An Coimisiún Pleanála
64 Marlborough Street,
Dublin 1

6th July 2026

Re: Case reference: PAX12.324290 10 year planning permission for
Lissinagroagh Wind Farm consisting of 14 no. wind turbines and all
associated infrastructure

Figure 1 below is an extract from The EPA Water Quality Status Maps and shows the good water status of the Owenmore River headwater streams within the proposed site.

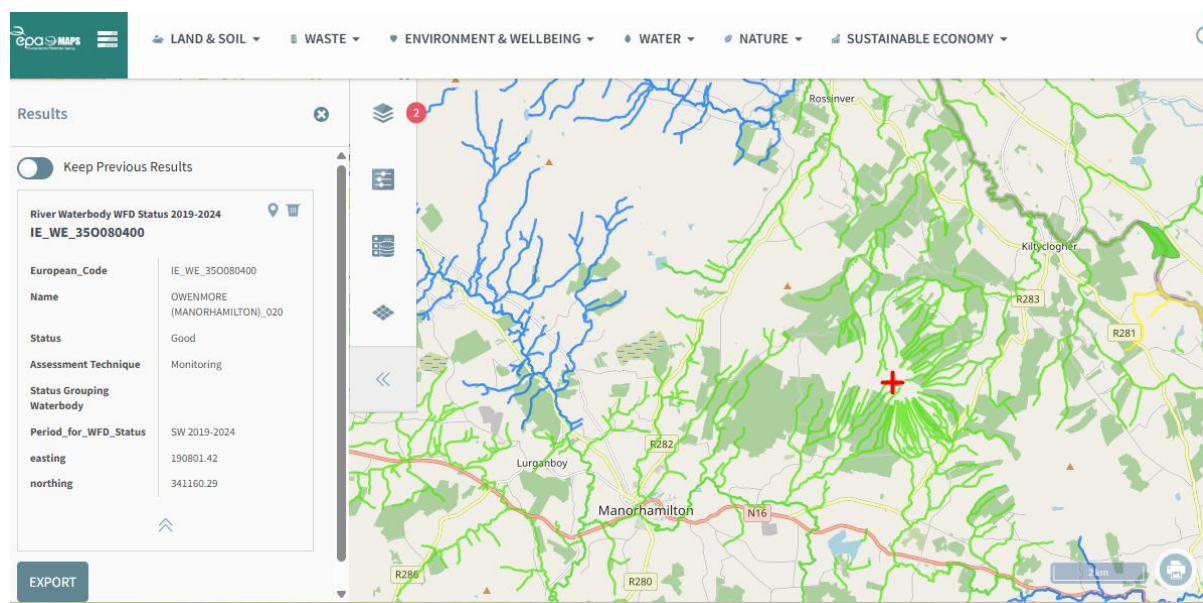
The site is located in two very sensitive water catchment areas. These are the Lough
Gill SAC and The Lough Melvin SAC. The head waters of the Owenmore River are
located on the south side of the site (T13 and T14) as well as the west side of the
site (T8, T9, T10, T11, and T12). These small upland streams flow into the
Owenmore River, a tributary of The Bonet River which flows into Lough Gill. On the
northern part of the site (T1, T2, T3, T4, T5, T6, and T7) the site drains to The
Lattone River, a tributary of The County River which flows into Lough Melvin. The
risk to these important SAC areas posed by the construction phase of the proposed
development is unacceptable. The headwaters of the main streams in the area
require the highest protection. Under the Water Framework Directive there is an
onus on the local authorities to maintain the high water quality status of these
streams. Therefore, this proposed development should be refused planning
